Objection submission COM/2019/81 - Groundwater impact

Please find below further information that I think should be considered re this development Application and its Environmental Submission re the effect on the groundwater and the Coomera River

## Attachment A2 - Cross section at B-B

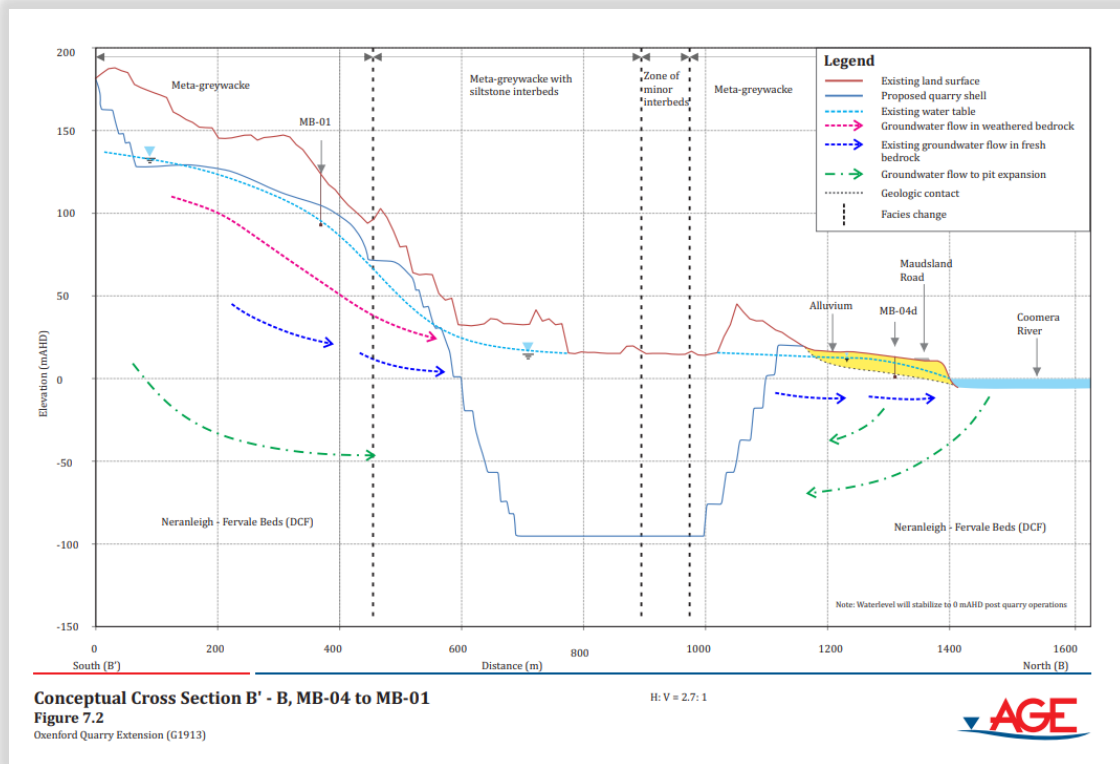
Figure 6.1 from the Groundwater Impact Assessment document shows where the cross sections are taken from (Reproduced in Attachment A1). The Conceptual Cross section B-B Is reproduced in Attachment A2. This clearly shows how the existing groundwater that currently flows into the Coomera River will be reversed and the Groundwater will instead be leaching into the quarry pit.

Unfortunately the effect on the water table is not shown in this pictorial. However, it can safely be assumed it would have a major effect.

## Attachment A3 - Cross section at B-B

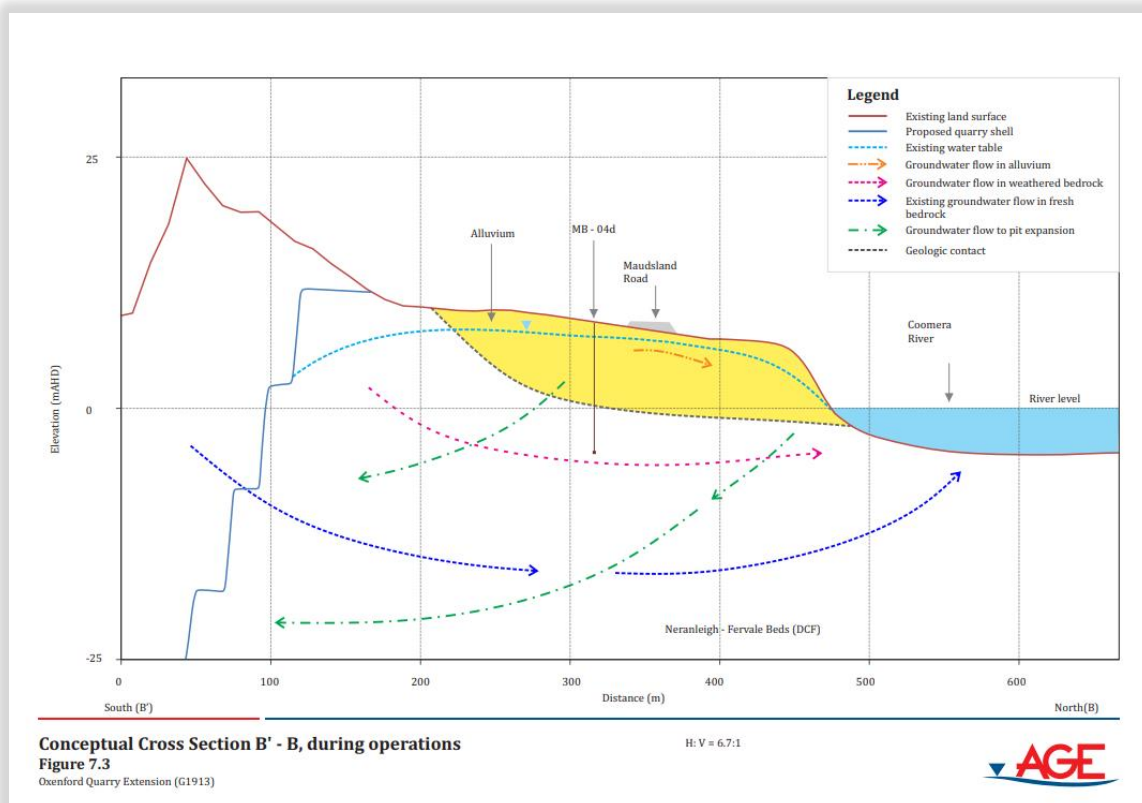
Conceptual Cross Section B-B (Attachment A3) does not, I believe show appropriately how close the proposed quarry pit will be to the Coomera River. As such I have endeavoured to produce an accurate cross section at the intersection of the John Muntz Bridge (Attachment A4). The cross-section position is shown on Attachment A5.

## Attachment A4 - Cross section at John Muntz Bridge

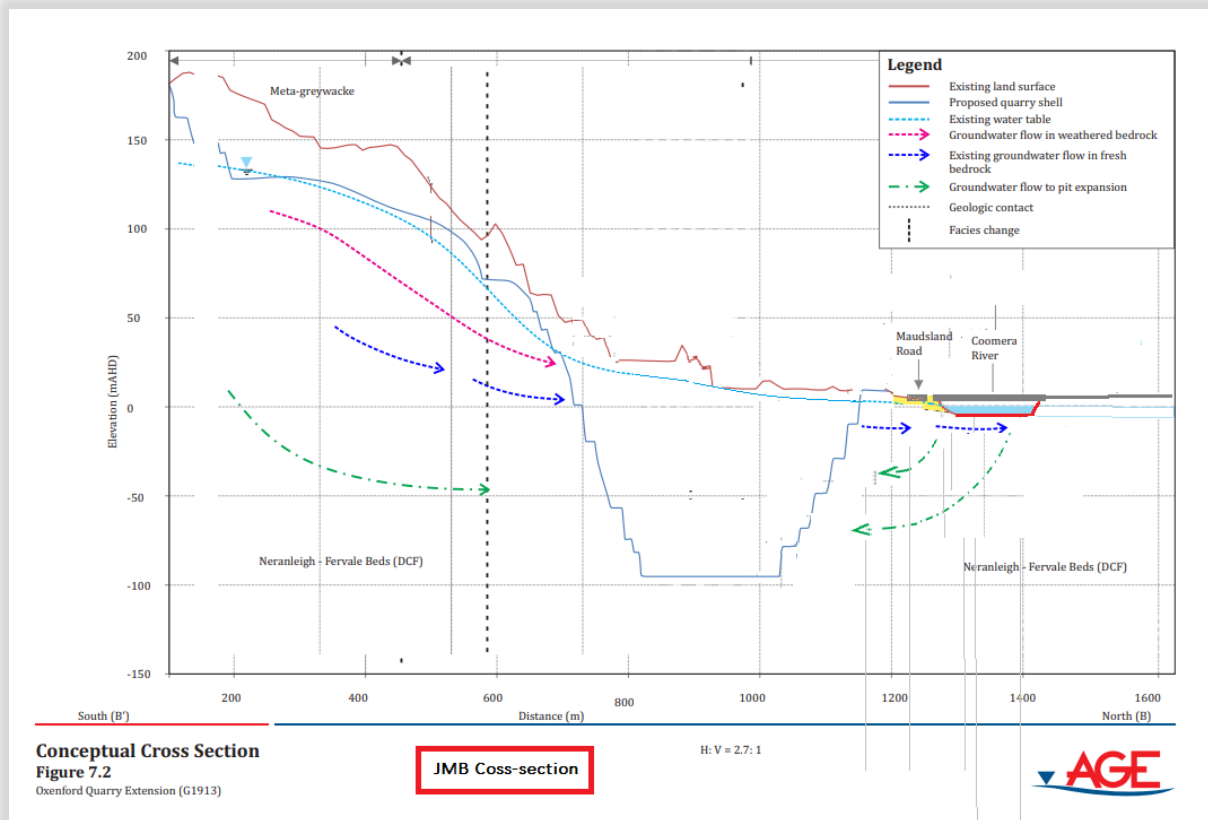
The scale of the proposed excavation, compared to the size of the Coomera River can be clearly seen from Attachment A4. It can clearly and worryingly be seen how the existing groundwater that flows towards the Coomera River will be reversed and will leach water from this freshwater source of the Coomera River (pre weir). The existing water table is going to be severely effected as it is very close to the surface and is currently above the Coomera River.

This will obviously affect all the bores within the radius of influence. But how will it affect the Coomera River approximately 80 metres of the subterranean excavation? Attachment A4 shows how the existing scenario allows ground water to flow into the Coomera River and thus showing the bottom of the water table to be 0m AHD in line with the Coomera River level. However, excavating below the Coomera River level will drastically change this current equilibrium and see the Coomera River instead leach into the quarry excavation pit (Attachment A4). There could well be serious problems in attempting to lower the water table so far below the Coomera River Level.

**Figure 7.6 Analytical model - inflow into quarry and drawdown (after Marinelli and Niccoli, 2000)**

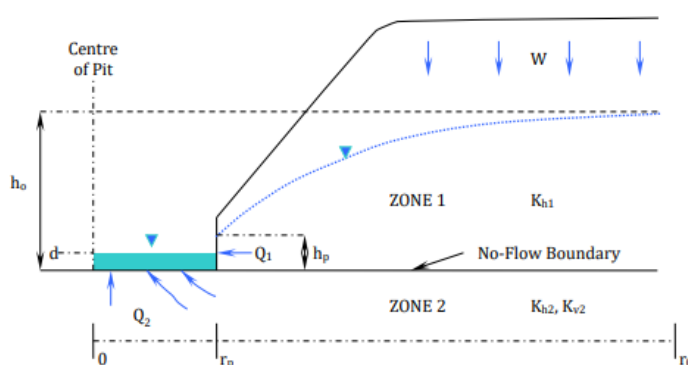
From the development application the total water inflow will be between 128.7 ML/yr (best case) and 431.6 ML/yr (Worst case) as reproduced in Attachment B1. This is equivalent to between 51 and 172 Olympic swimming pools of ground water, leached from the surrounding area into the quarry excavation.

**Total water inflow between 128.7 ML/yr (best case) and 431.6 ML/yr (Worst case)**  
**This is equivalent to between 51 and 172 Olympic swimming pools**

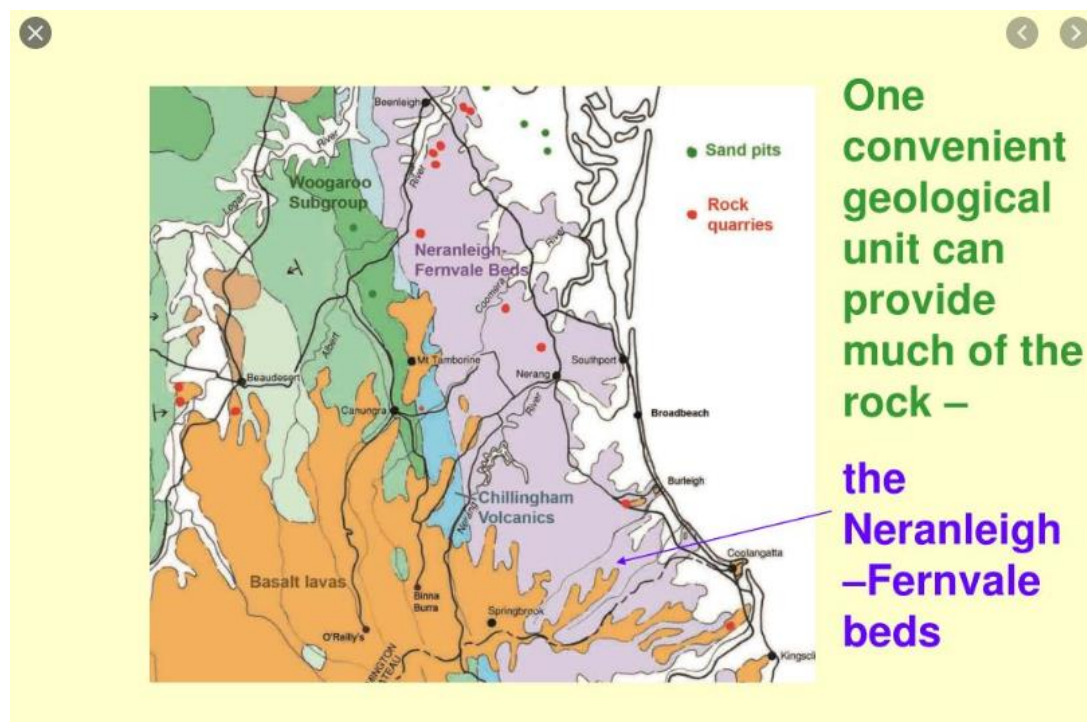
Section 6.1.2, of the Groundwater assessment (Reproduced in Attachment B2) discusses whether the Neranleigh-Fernvale Beds is an aquifer or a 'water-bearing unit'. It incorrectly, in my opinion, chooses to treat the area as a 'water-bearing unit' as it claims: "there are very few bores completed in the Nerang-Fernvale Beds that provide useable volumes of water that meet either the fresh water or drinking water guidelines".

However, a cursory glance at the "DNRME GWDB bore locations map (Submitted as Figure 5.1, and reproduced as attachment C3) shows there are 18 bores just within 1.4km radius of the Nucrush quarry (Yellow outline). The Neranleigh-Fernvale Beds is a large expansive area stretching from Brisbane down beyond the NSW border. Therefore, I believe to dismiss this as an aquifer is incorrect.

**Therefore, the Neranleigh-Fernvale Beds (identified in Attachment B3) is clearly an 'aquifer', however impact assessment considers it, incorrectly, as a 'water-bearing unit' for its impact assessment. It is abundantly clear the Neranleigh-Fernvale Beds are far more than that.**

The Neranleigh-Fernvale Beds are clearly an 'aquifer', however impact assessment considers it, incorrectly, as a 'water-bearing unit' for its impact assessment

Radius of influence is between 700m and 1418m

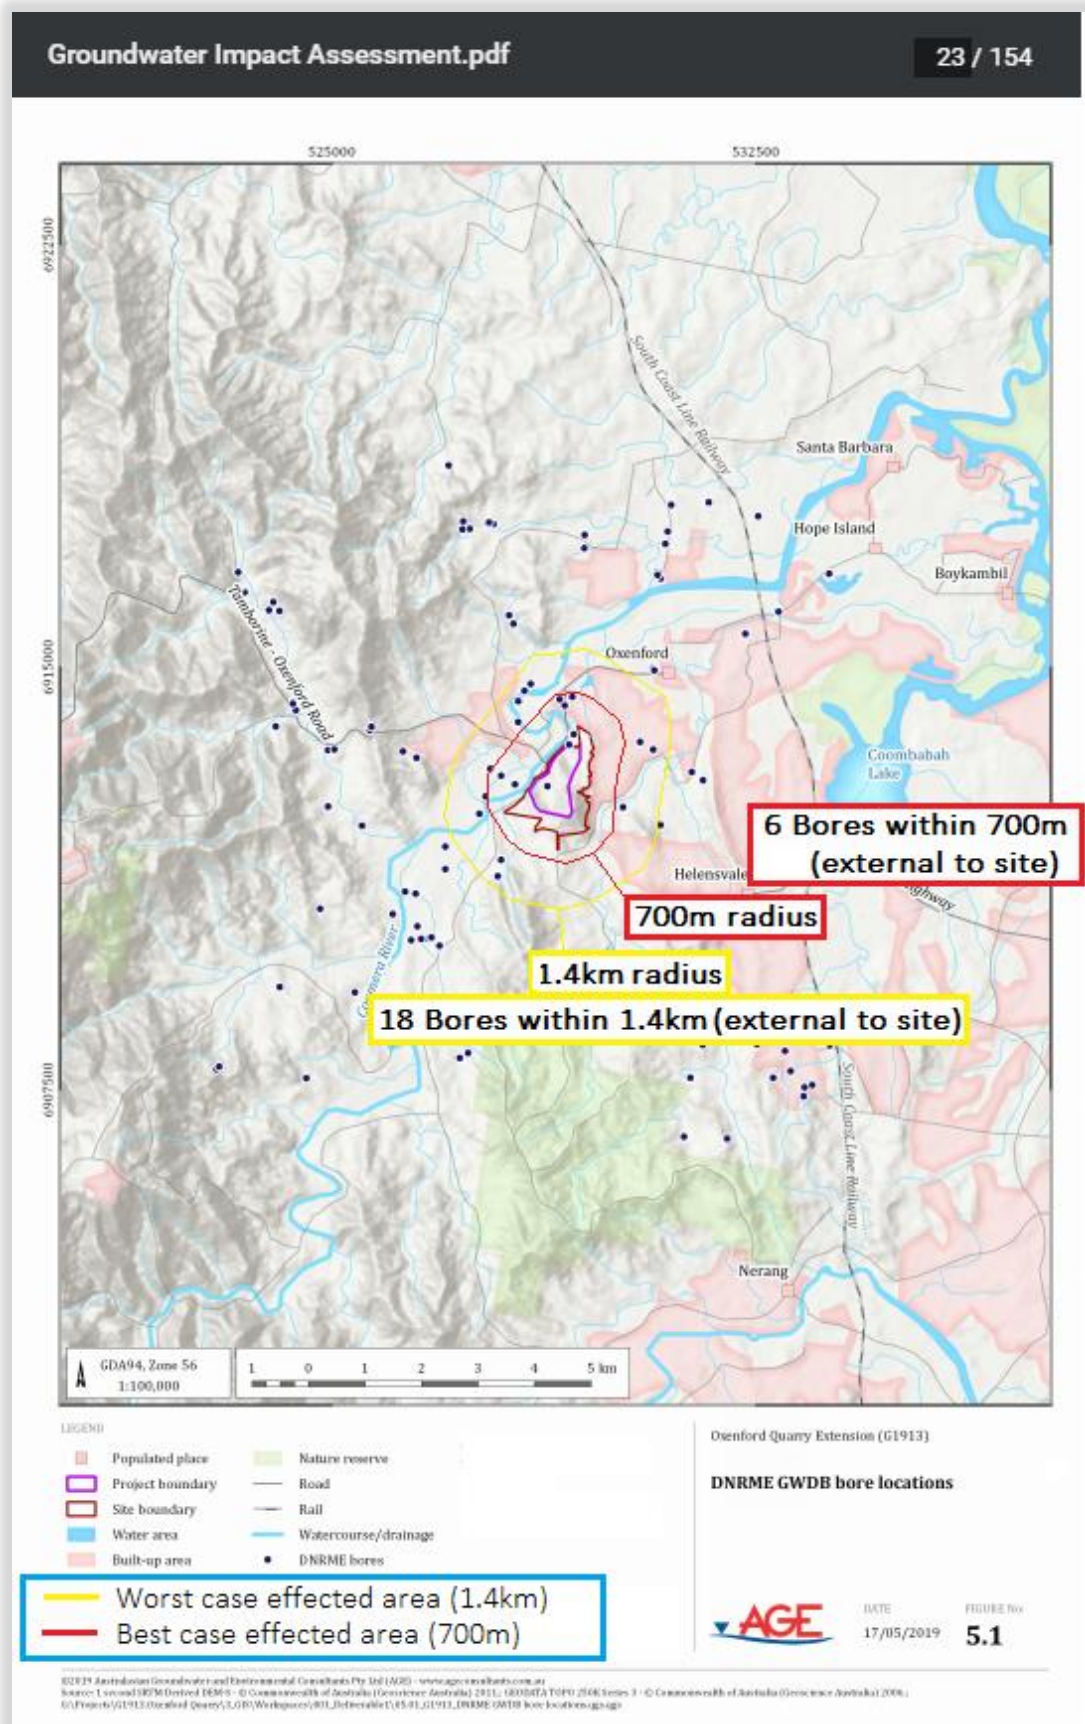
The Radius of Influence submission (Section 7.4, reproduced in C1) demonstrates how the proposed excavations will have either a 700m (low permeability bedrock) or 1418m radius of influence (high permeability bedrock).

Firstly, with the test bores that have been carried out I would expect the quarry to be able to tell if the bedrock was low or high permeability? However, we must assume worst case.

The radius of influence will be an area of over 6km<sup>2</sup> around the quarry. Therefore, all of this area will see a drop in the water table. How will this affect the area?

The bore location map (Attachment C2) shows there are eighteen legal bores within this area. The artificial lowering of the water table could have severe effects on these bores.

This is within the Radius of Influence as shown in Attachment C2.

## Attachment C4 - Bore RN124033 Statistics

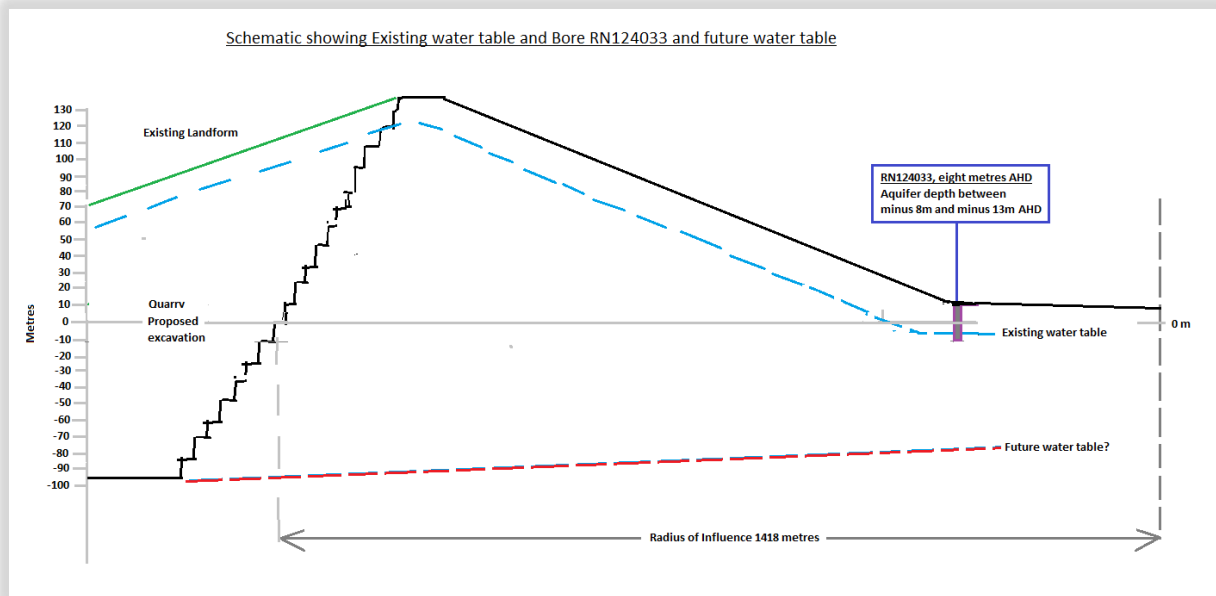
This is further emphasised by the 'Bore Report' for Bore RN124033, approximately 1.1km from the quarry, identified geographically in (Attachment C3). The Bore Report (Attachment C4) clearly identifies three aquifers at this location at 15m at 20m and at 21m.

It can be seen from the bore report that the bore traverses three aquifers at 15.85m, 19.80m and 21.35m (Bore Report, Attachment C4). This bore is 8m AHD. Therefore the aquifers are approximately between 8m and 13m below the Coomera River Level (0m AHD).
